SERVICE BULLETIN

SERVICE BULLETIN NO: 28-004

FUEL - DISTRIBUTION ENGINE DRIVEN PUMP - TORQUE CHECK OF RELIEF-VALVE-BODY SCREWS

Torque Check and Fuel Leak Inspection of the EDP
Figure 1

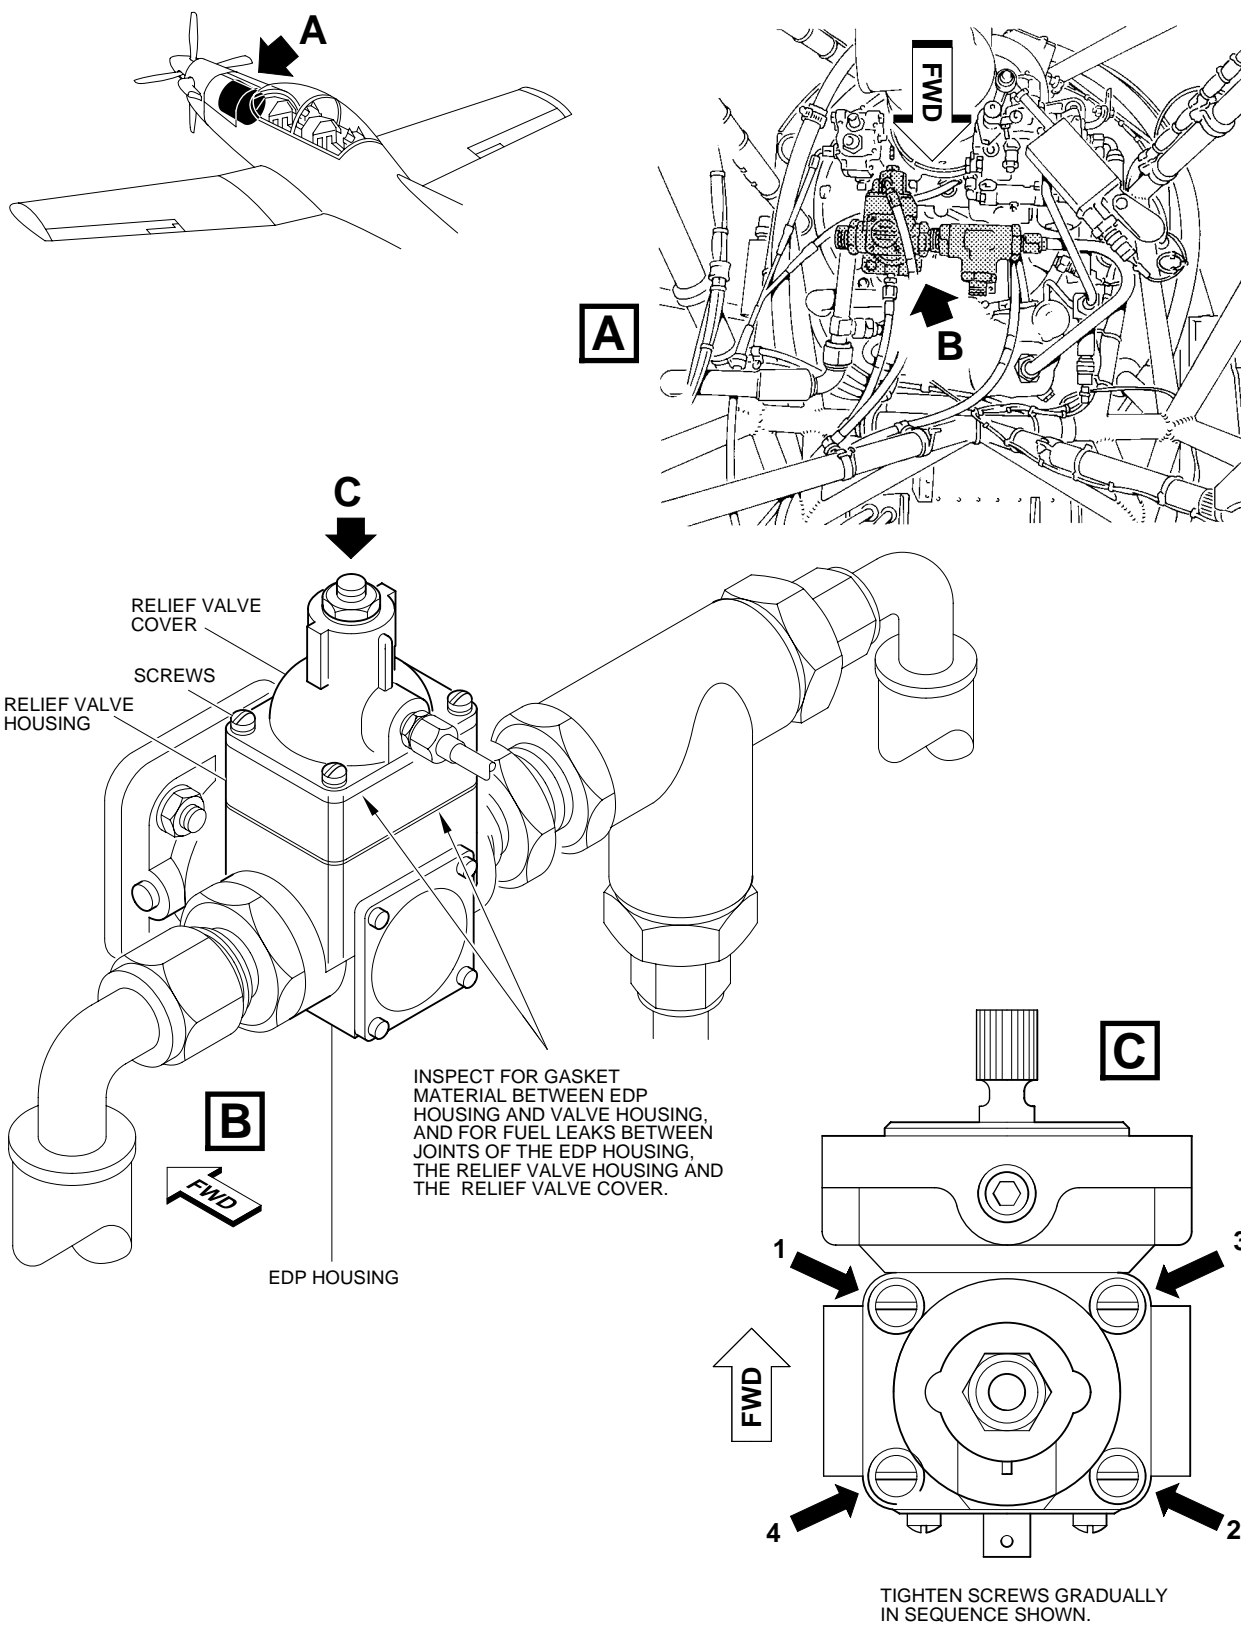
- (1) Visually inspect the joints between the EDP housing, relief valve housing and the relief valve cover for:

- Fuel leakage
- Gasket material pushed out

- (2) If the EDP shows signs of fuel leakage or the gasket between the EDP housing and the relief valve housing has been pushed out, replace the EDP (Ref. AMM, 28-20-10, Page Block 401).

- (3) Use a torque screwdriver to do a check of the torque value of the relief-valve-cover screws. Do the check clockwise only. The minimum torque must be 23 lbf in. (2,6 Nm).

- (4) If the torque found at Step (3) is more than 23 lbf in. (2,6 Nm), it is not necessary to loosen the screws and torque them again.

- (5) If the relief-valve-cover screws are loose, or the torque found at Step (3) is less than 23 lbf in. (2,6 Nm), do as follows:

- (b) Torque the screws gradually to between 23 and 25 lbf in. (2,6 and 2,83 Nm). Do this in the sequence shown in Figure 1, Detail B.
